CANDLEWOOD SUITE HOTEL | CHERRY HILL SWEDISH CAMPUS

PLAN CHANGES FROM 09-11-2019 SAC MEETING - HOTEL PROPOSAL

505 16TH AVE, SEATTLE

P1 FLOOR PLAN - PROPOSED

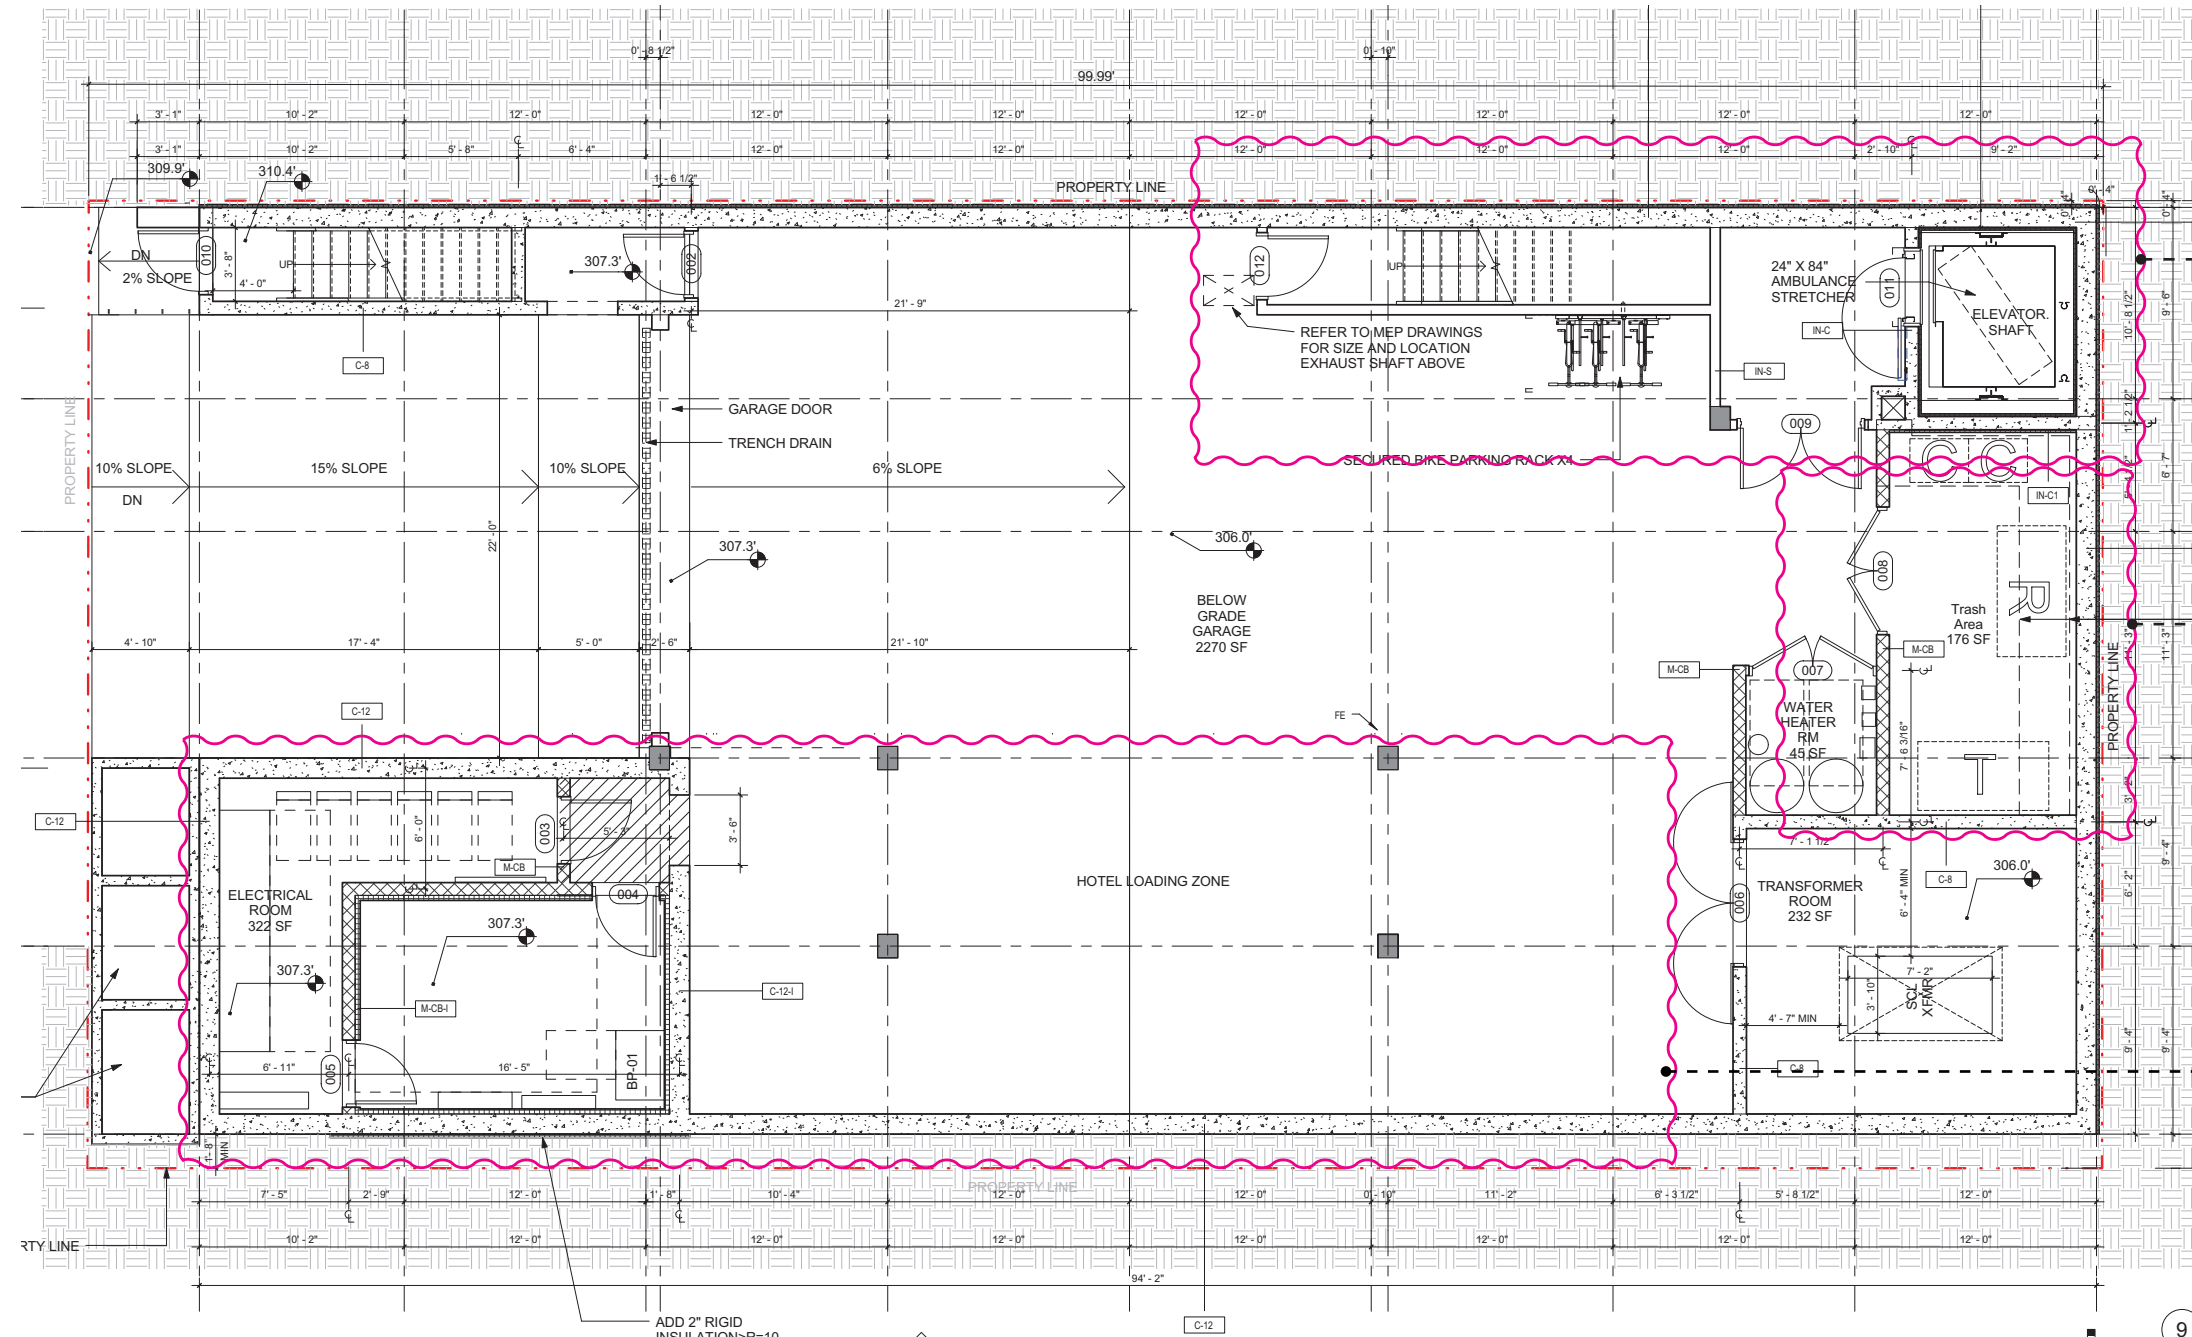
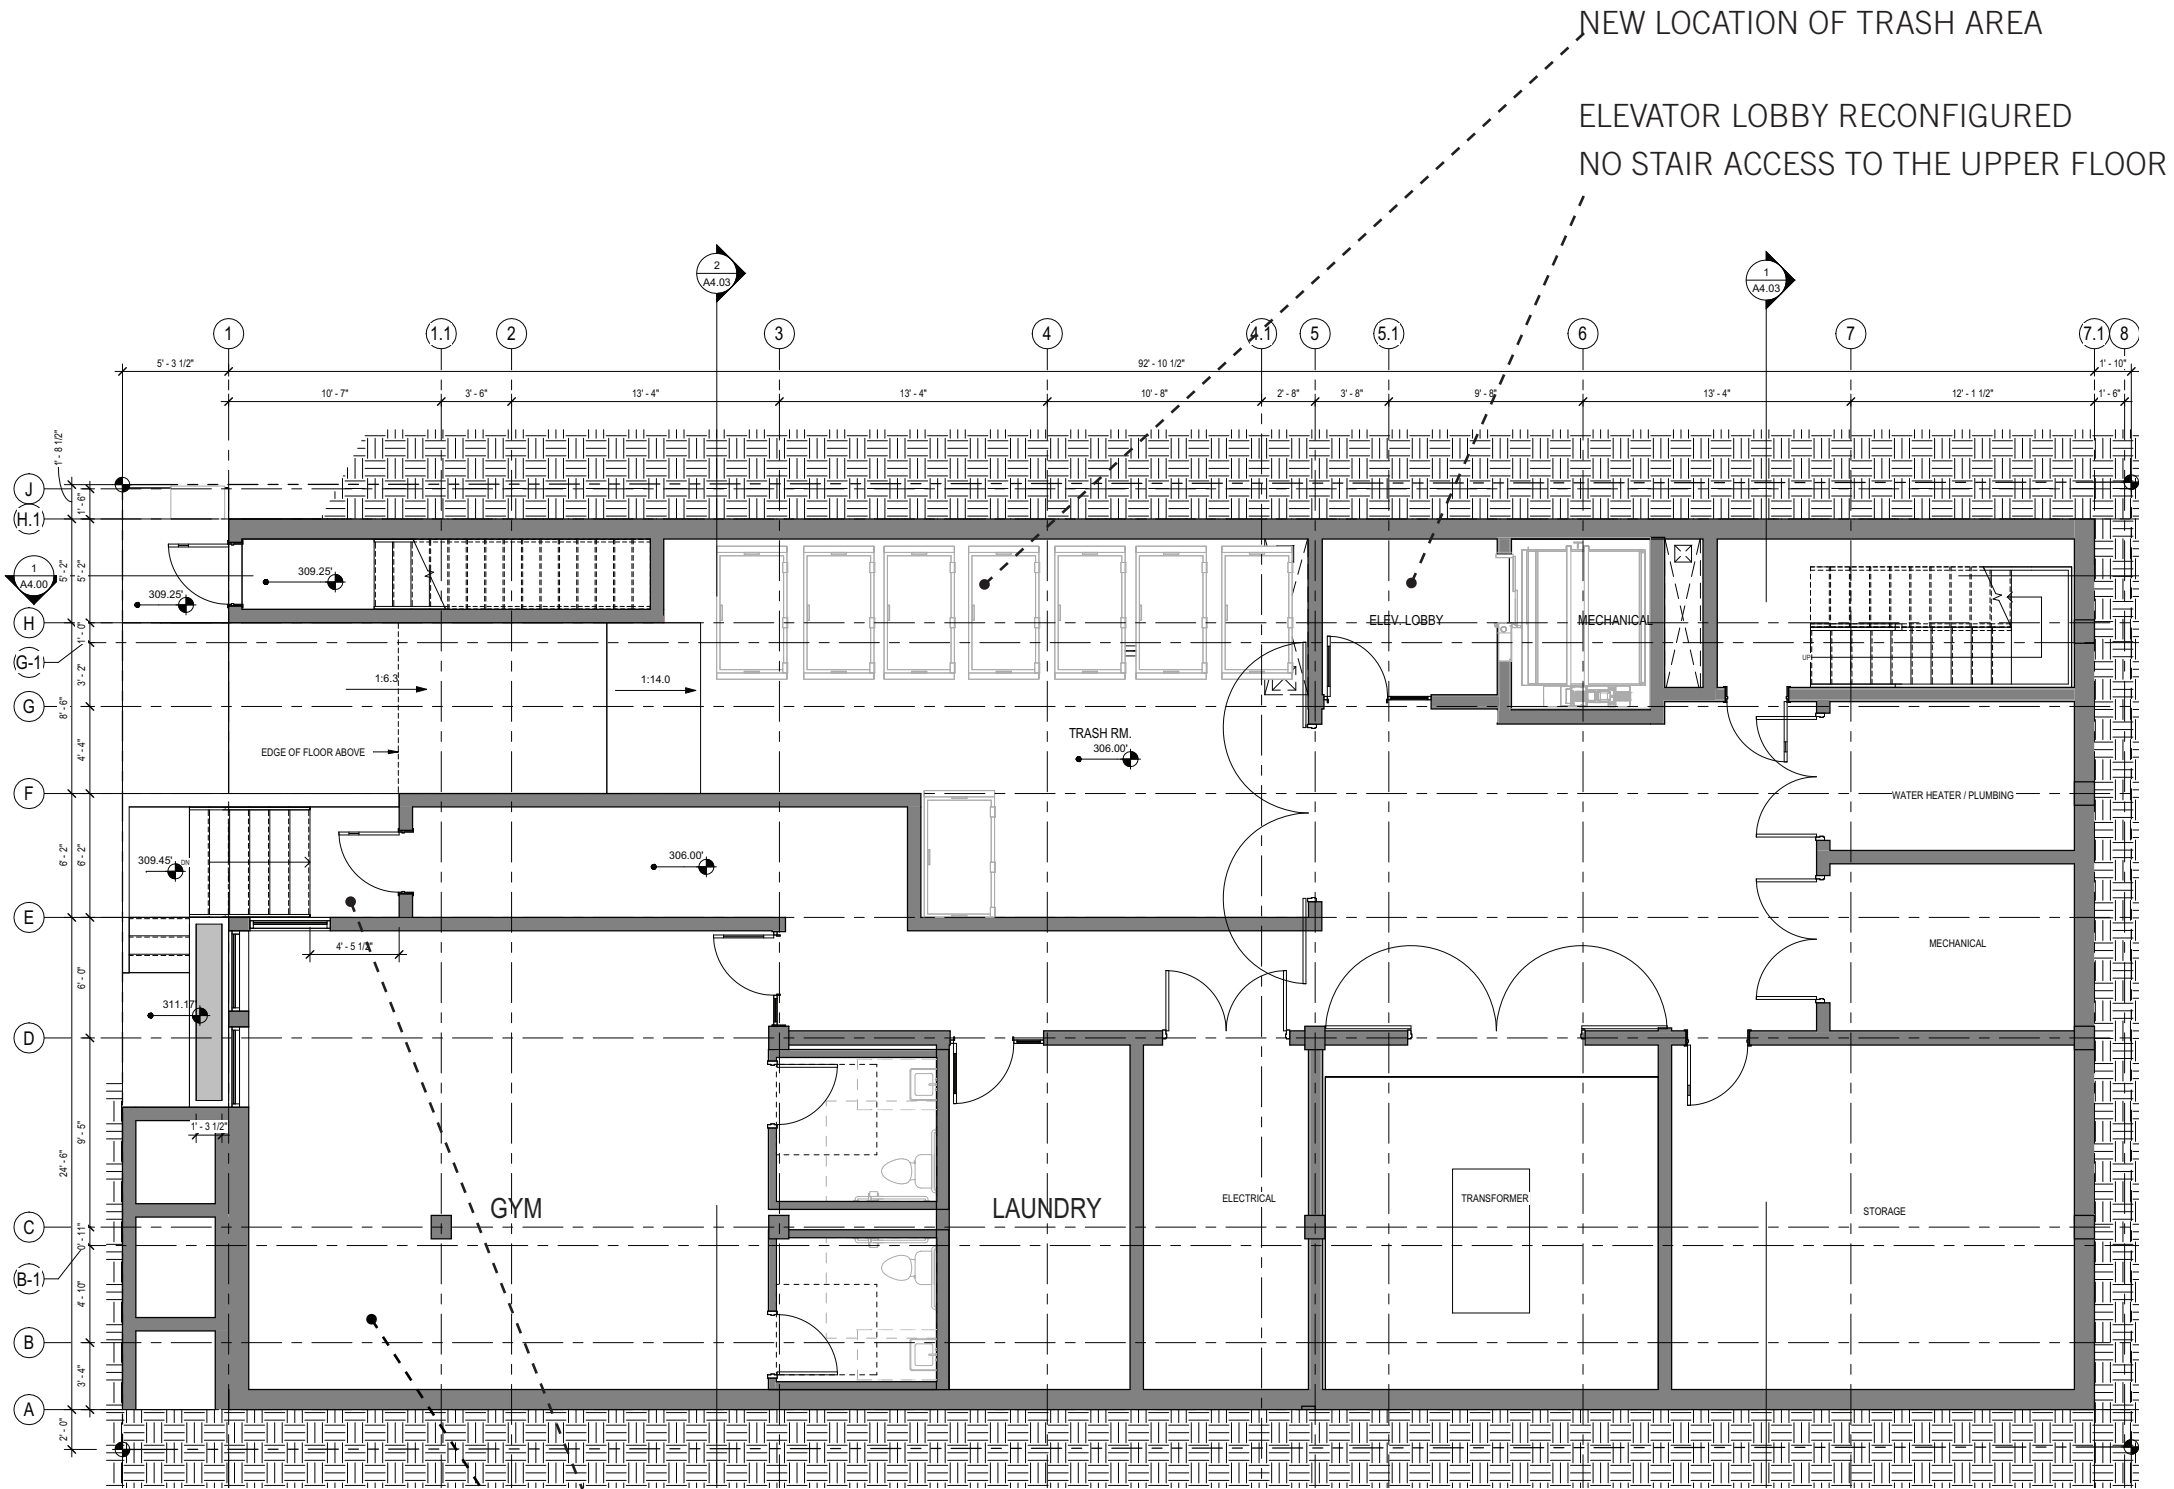
STAIR AND ELEVATOR HAVE BEEN REARRANGED TO MEET THE PROGRAMMING NEEDS AT UPPER LEVEL

LOCATION OF THE TRASH AREA CHANGED

LOCATION OF TRANSFORMER ROOM CHANGED

- UNDERGROUND PARKING IS ELIMINATED
- HOTEL LOADING ZONE ELIMINATED
- RAMP TO THE GARAGE IS REDUCED IN WIDTH

NEW LOCATION OF TRASH AREA
 ELEVATOR LOBBY RECONFIGURED
 NO STAIR ACCESS TO THE UPPER FLOOR

PEDESTRIAN ACCESS FROM JEFFERSON TO P1 IS ADDED
 ADDITIONAL PROGRAMMING AMENITIES ADDED
 - GUEST GYM WITH DAYLIGHT ACCESS (SOUTH ELEVATION)
 - CORNER GLAZING

MIMP PROPOSED CHANGES

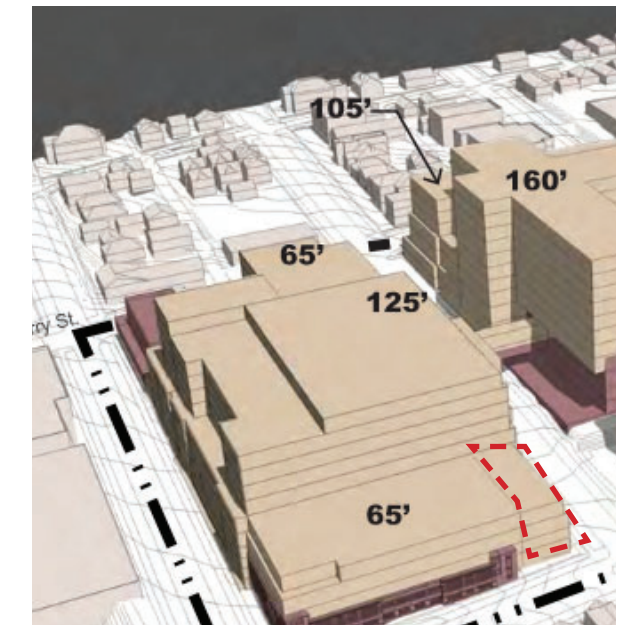
UNDERGROUND PARKING IS ELIMINATED IN ANTICIPATION OF EXPANSION OF PARKING STRUCTURE AT NORTH (SABEY GARAGE). PROPOSED MIMP INCREASED CURRENT ZONING HEIGHT FOR THAT AREA FROM 65' TO 125', THEREFORE INCREASING PARKING AVAILABILITY FOR THE CAMPUS
